"HIGHLAND ESTATES, LOT 9"  
2185 COBBLEHILL PLACE  
SAN MATEO COUNTY, CALIFORNIA  
THE CHAMBERLAIN GROUP  
655 SKY WAY, SUITE 230  
SAN CLEMENTE, CALIFORNIA 94076  
PHONE (951) 365-5582 FAX (951) 365-5666

Subject: Highland Estates, Lots 9-11, San Mateo  
BKF Response to County Planning Department Setback Comments

Re: Planning Comments on Lots 9-11

From: Camille Leung, Senior Planner

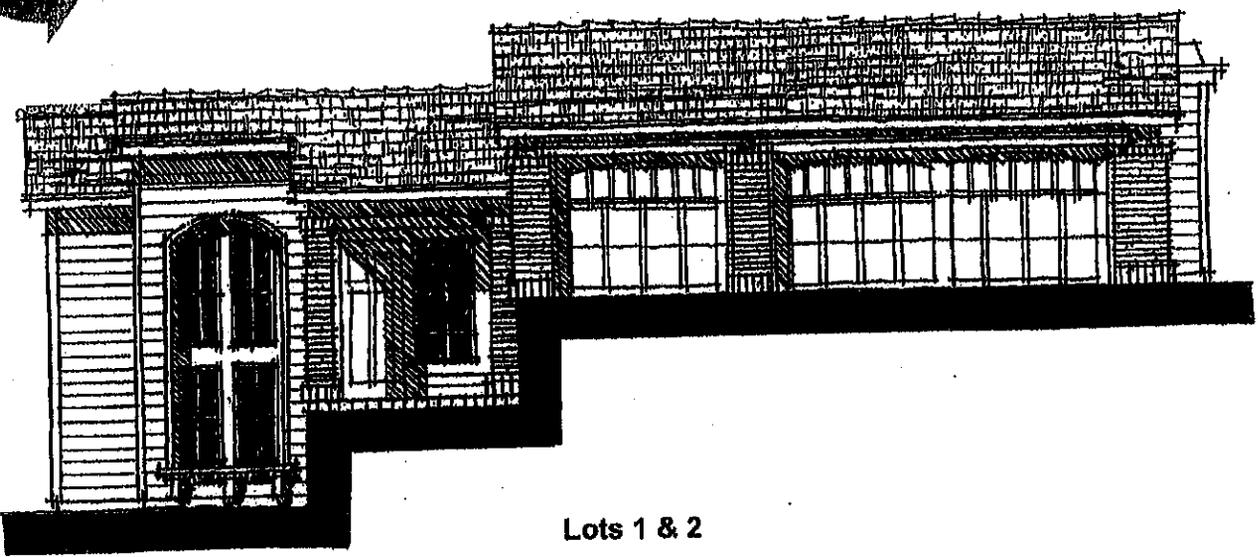
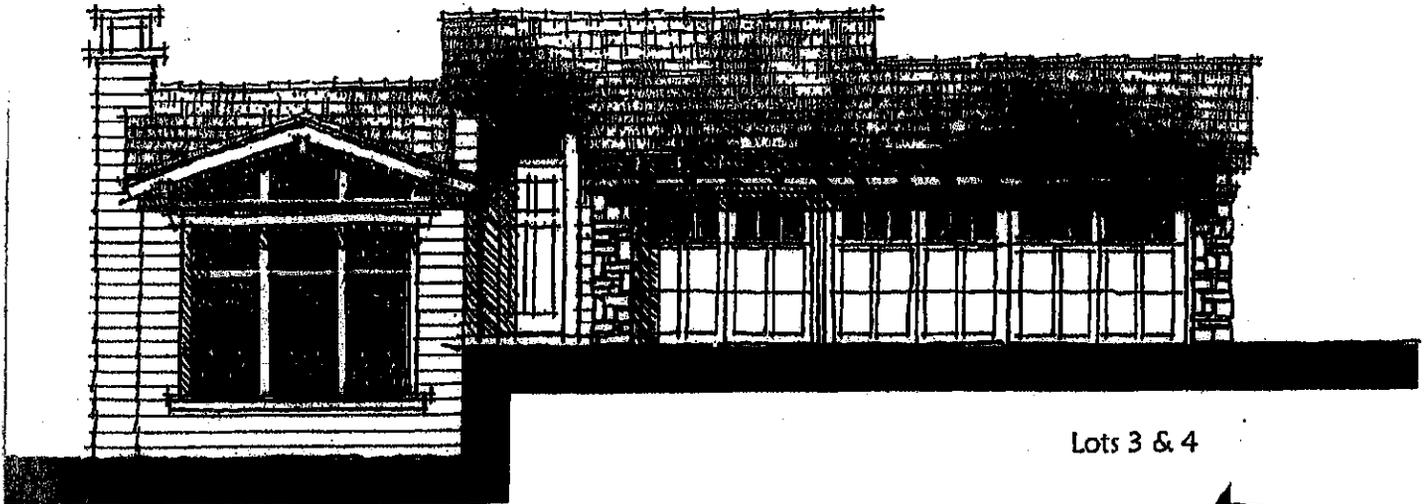
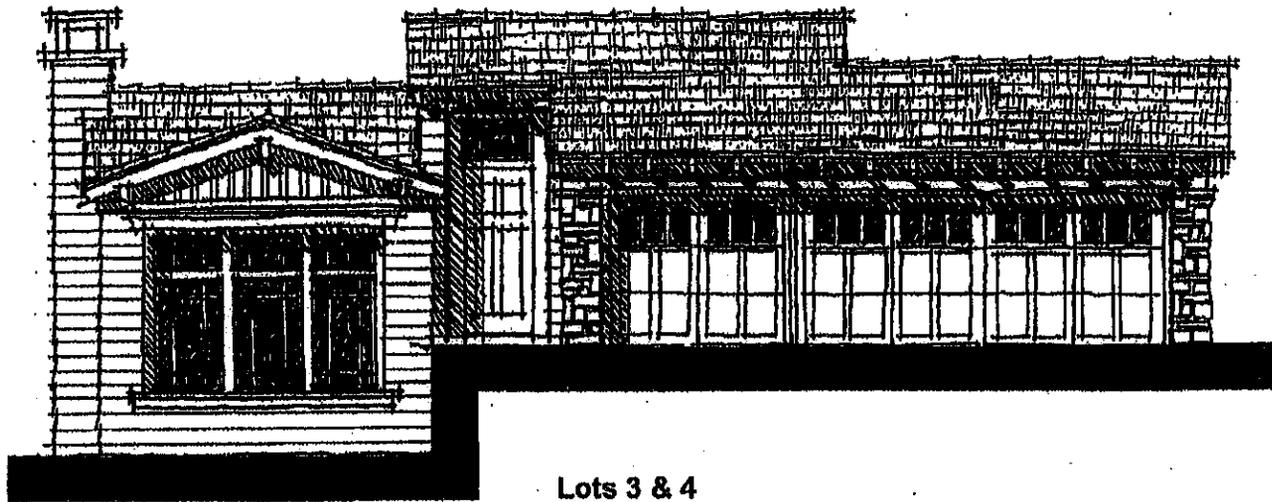
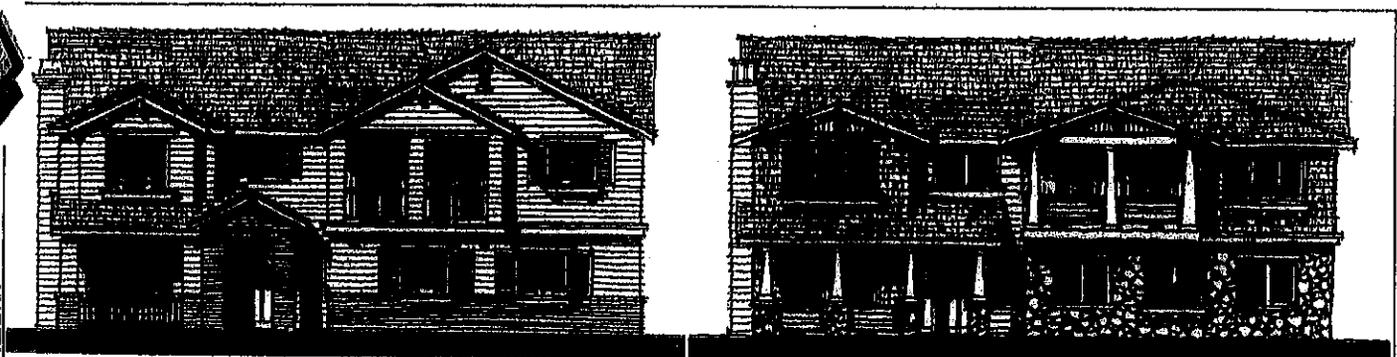
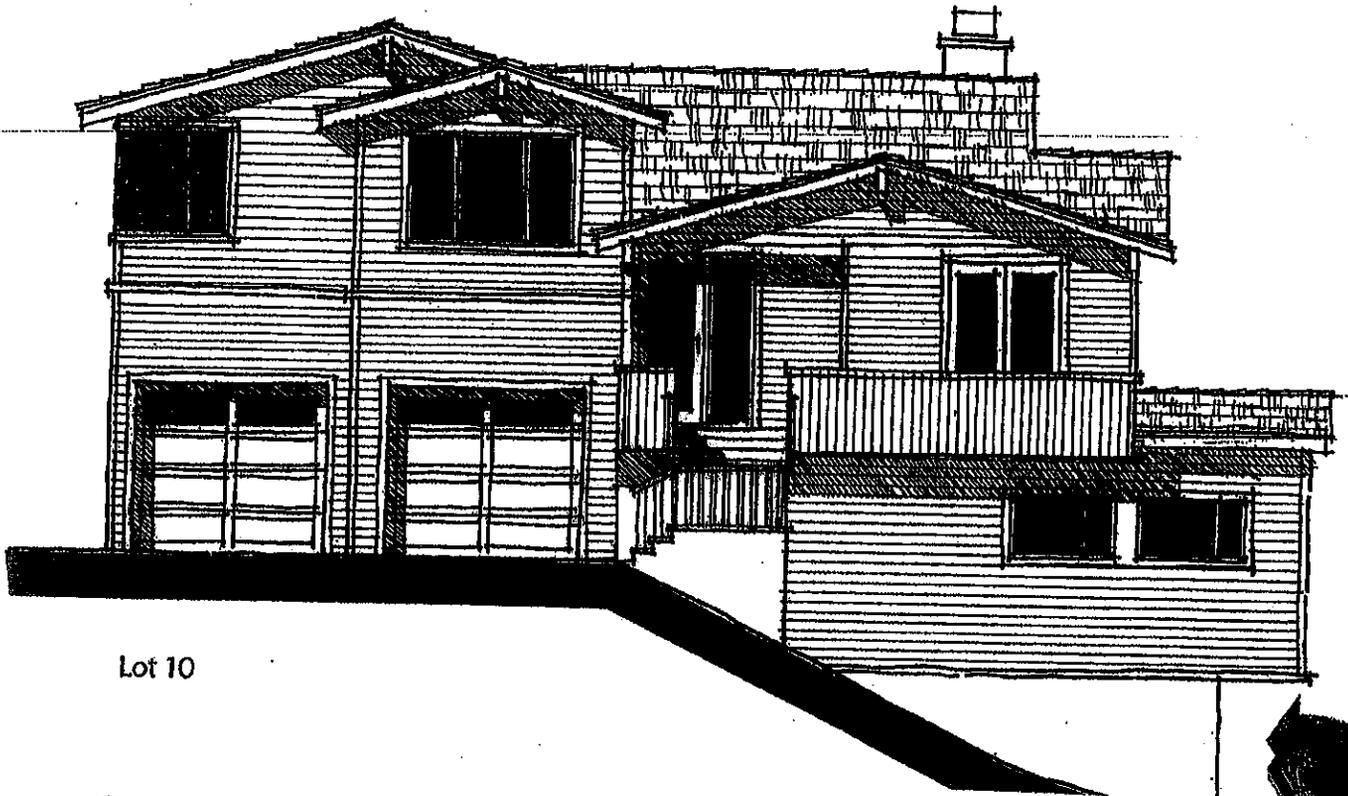
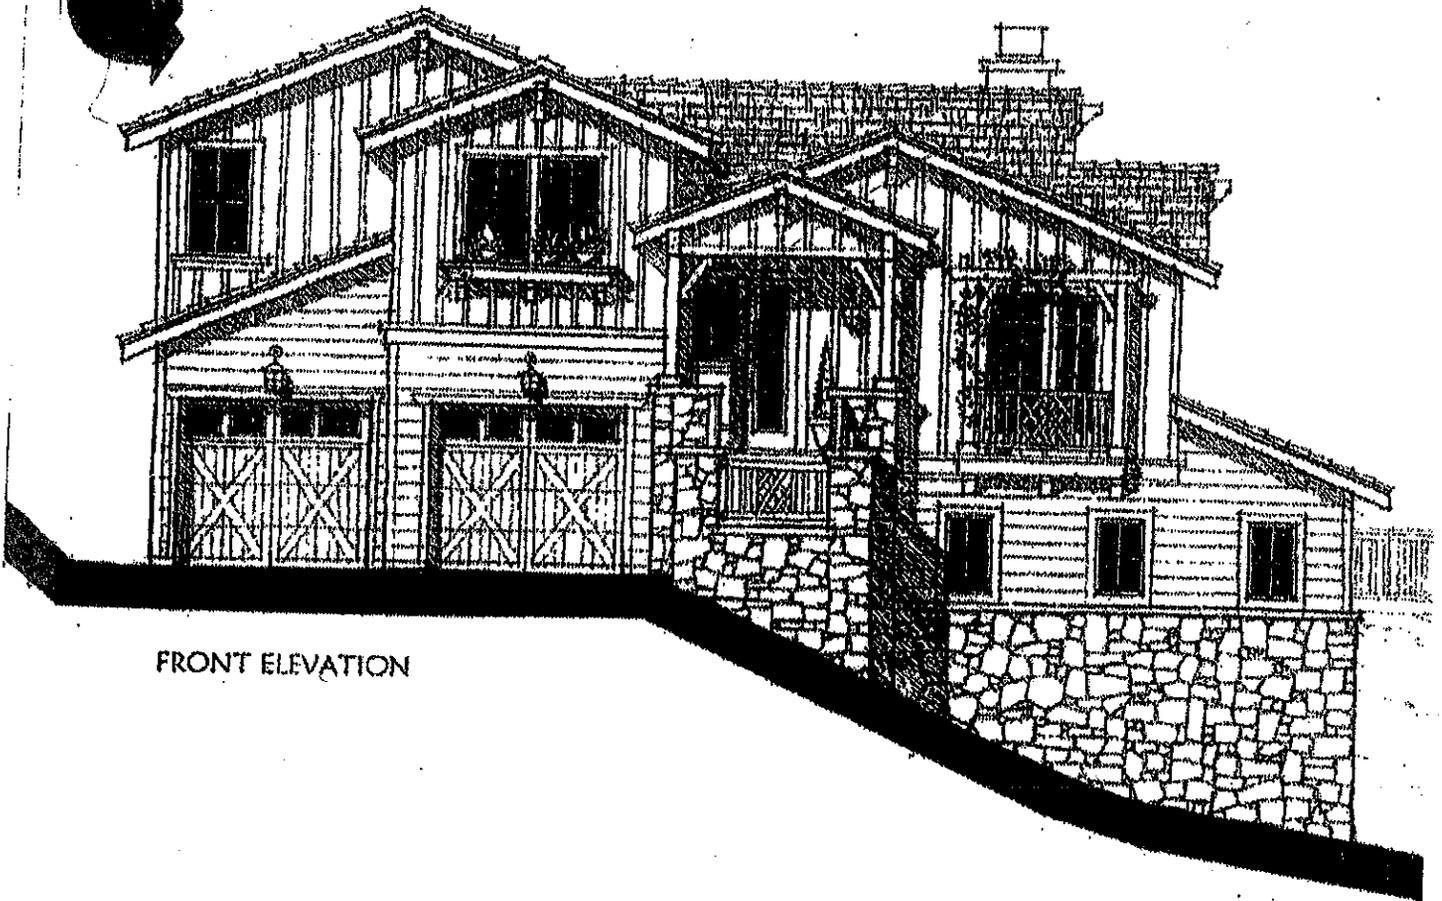
Here are some things that could be done on the homes to give them a more Eichler appearance. 9 and 11 could be treated similarly.

Last 200 yards of Cobblehill Place.

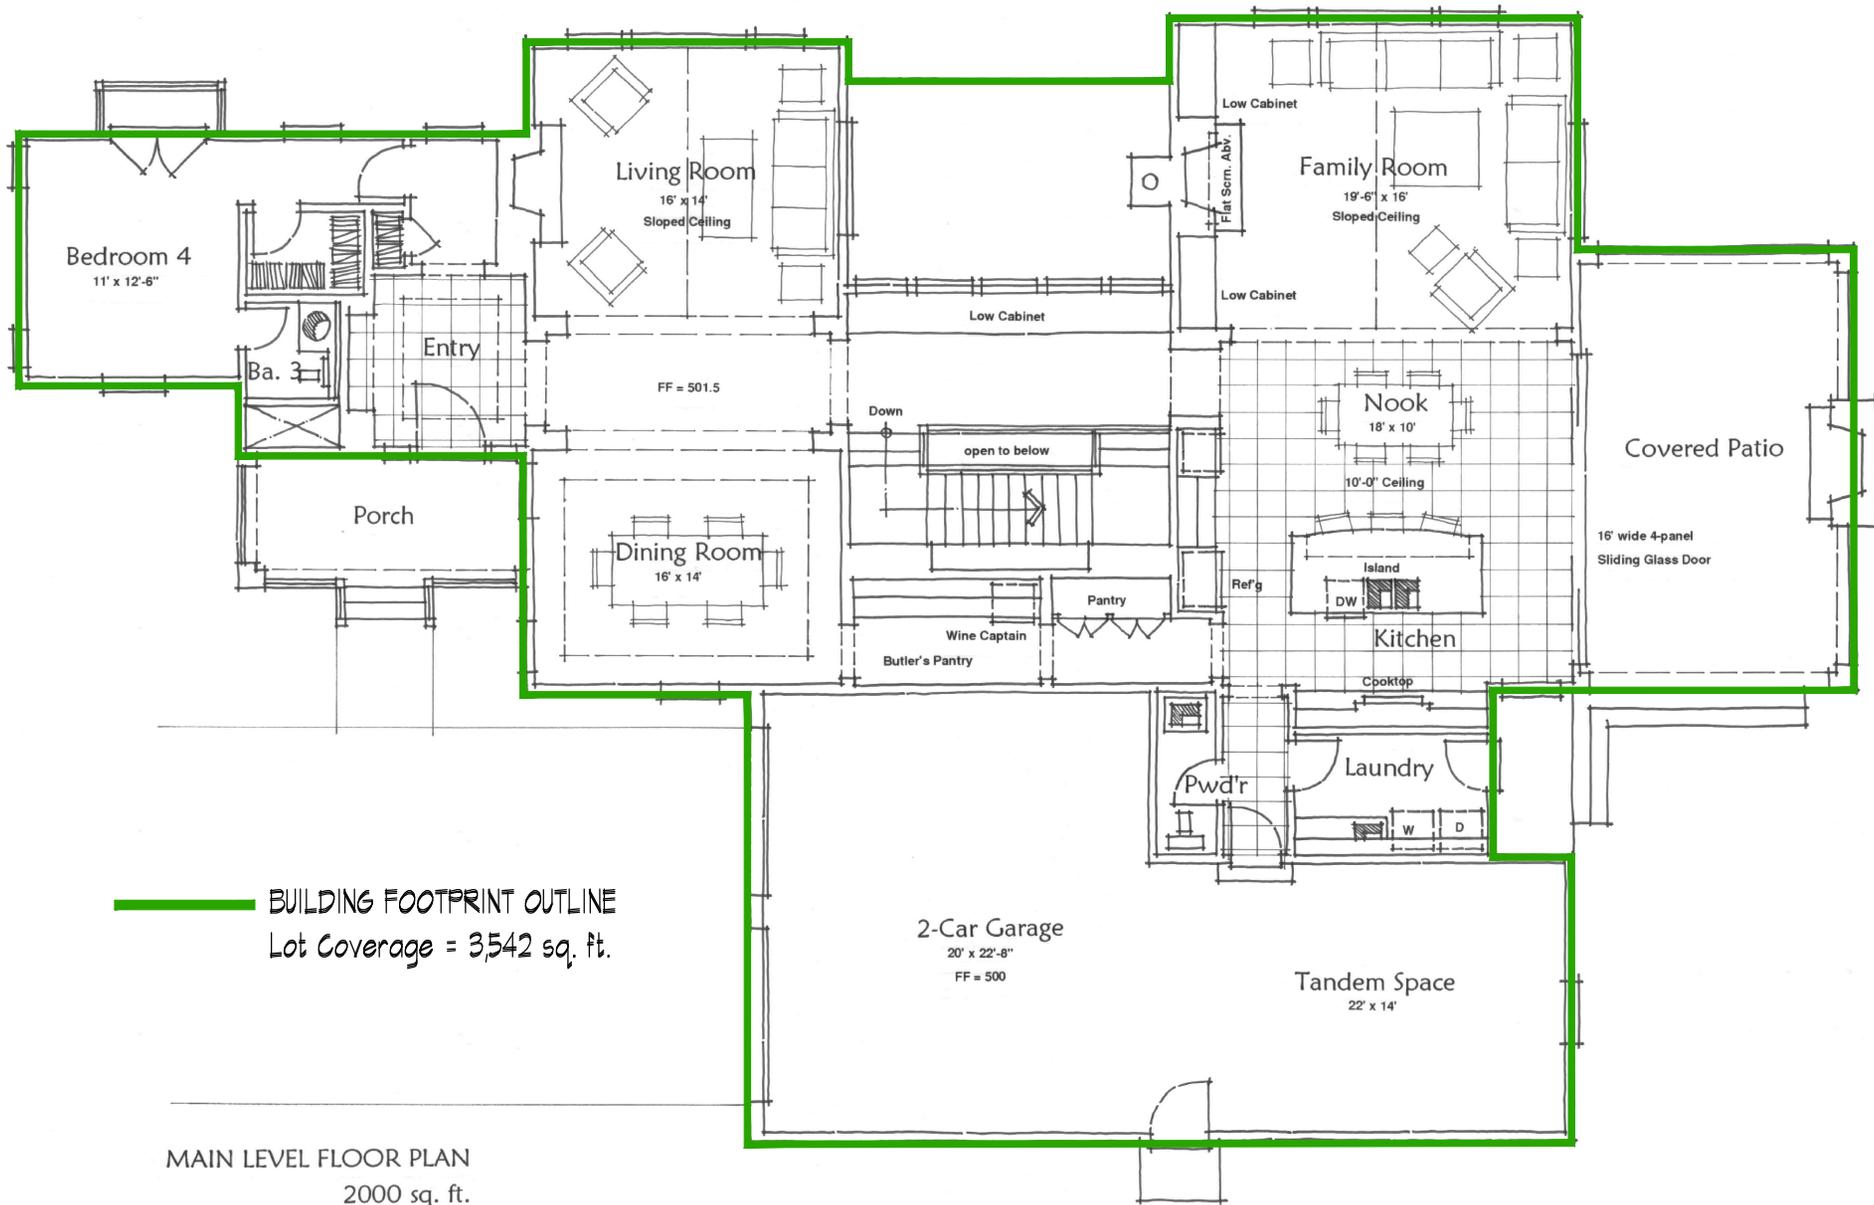
Constant standing water causing breakdown of existing pavement.
